**Nature of Work:** TEAR OFF & RESHEET 49 SQ'S ROOF APPLY MONIER LIFETILE DURALITE TILE.

re: Job 2001\_240: TORRES

Subject: Structural Investigation Report of the Roof for the Residence located at 6691 Spurlock Way, Sacramento, CA 95831.

**ROOF PLAN - TORRES**

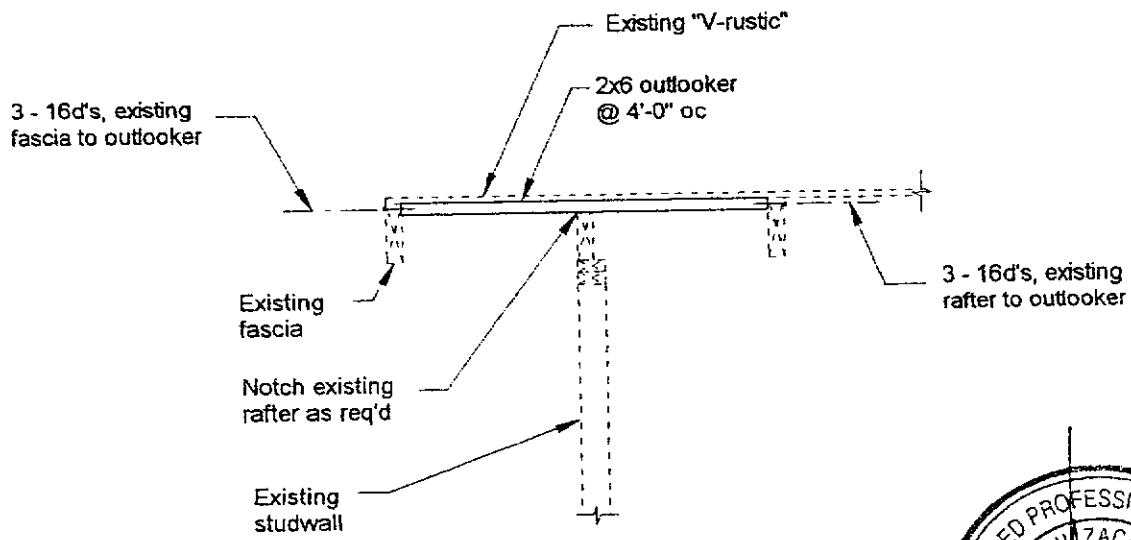
The roof structure currently lacks sufficient structural capacity for the applied live and dead loads. See "Recommendations" for location and repair to bring the roof structure up to the required capacity.

1. Add 2x6 outlookers at 4'-0" (total 19). See detail 2.
2. Scab a 2x6 to existing 2x6 rafters where the span is greater than 12'-0" (total 20).
3. Scab a 1 3/4" x 11 1/4" LVL to the existing 4x12 beam. See detail 3.
4. Add 2x4 x 18" nailers with 6 - 16d's to each 2x4 strut (total 5). See detail 4.
5. Add a 2x6 x 12'-0" long purlin with 2x4 struts to bearing below.
6. Add a 2x6 x 16'-0" long purlin with 2x4 struts to bearing below.

1. Add 2x6 out lookers spaced at 4'-0" on center. See details 1 and 2.
2. Scab a 2x6 rafter to the existing 2x6 rafters with 16d's @ 12" on center where the span is greater than 12'-0". See detail 1.
3. Scab a 1 3/4" x 11 1/4" LVL to the existing header. See details 1 and 3.
4. Add 2x4 x 1'-6" long nailers to the existing 2x4 struts with 6 - 16d's. See details 1 and 4.
5. Add a 2x6 DF#2 x 12'-0" long with 2x4 struts to the bearing walls below. The maximum spacing between the struts shall not exceed 6'-0" on center and the minimum slope of the struts shall not be less than 45 degrees from the horizontal. See detail 1.
6. Add a 2x6 DF#2 x 16'-0" long with 2x4 struts to the bearing walls below. The maximum spacing between the struts shall not exceed 6'-0" on center and the minimum slope of the struts shall not be less than 45 degrees from the horizontal. See detail 1.
